Access Compliance Report

Public Rights-of-Way

(Curb Ramps)

Intersection ID: N/A	Main Street: ARDREY_KELL_DR	Cross Street: N/A	Location: NW
ADA ID: 79FFDE00C8BE	Ramp Type: PerpDiag	Initial Pass/Fail: Fail	Overall Compliance: No
			Severity Score: 21.25

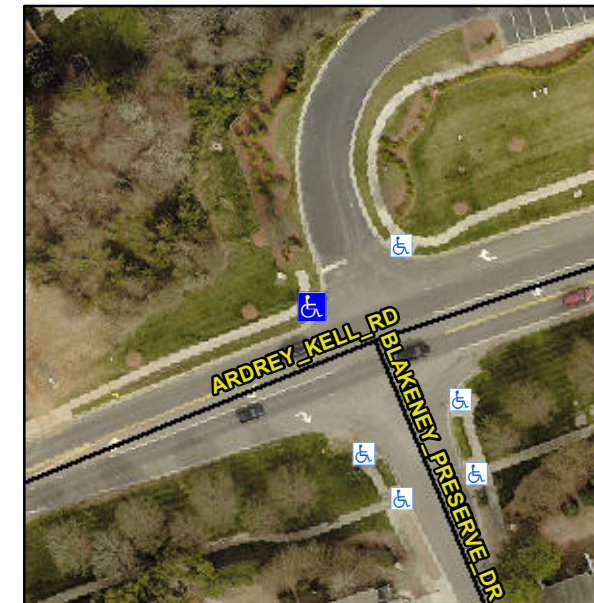
R304.5.1, R304.2.2

Compliance	Description	Data	Compliance	Description	Data
N/A	Ramp Length (in)	80.0	No	Ramp Slope (%)	9.6
No	Ramp Width (in)	38.0	Yes	Ramp XSlope (%)	0.9
N/A	Flare Type LT	N/A	N/A	Flare Type RT	N/A
N/A	Flare Slope LT (%)	N/A	N/A	Flare Slope RT (%)	N/A
N/A	Flare Traversable LT?	N/A	N/A	Flare Traversable RT?	N/A
N/A	Landing Length (in)	N/A	N/A	DWS Provided?	N/A
N/A	Landing Width (in)	N/A	N/A	DWS Contrast?	N/A
N/A	Landing Slope (%)	N/A	N/A	DWS Length (in)	N/A
N/A	Landing X Slope (%)	N/A	N/A	DWS Full Width?	N/A
N/A	Landing Curb? (Y/N)	N/A	N/A	DWS Offset (in)	N/A
N/A	Shared Landing?	N/A			
N/A	Gutter Ponding?	N/A	N/A	Gutter Slope (%)	N/A
N/A	Gutter Lip Ht (in)	N/A	N/A	Gutter X Slope (%)	N/A
N/A	Painted X Walk1?	No	N/A	Painted X Walk2?	No
	X Walk 1 Direction	To SE		X Walk 2 Direction	To NE
N/A	X Walk 1 Width (in)	N/A	N/A	X Walk 2 Width (in)	N/A
	X Walk 1 Slope (%)	5.4		X Walk 2 Slope (%)	2.5
	X Walk 1 X Slope (%)	1.1		X Walk 2 X Slope (%)	1.6

Remove & Replace Curb Ramp With Two New Directional Ramps or Equivalent.
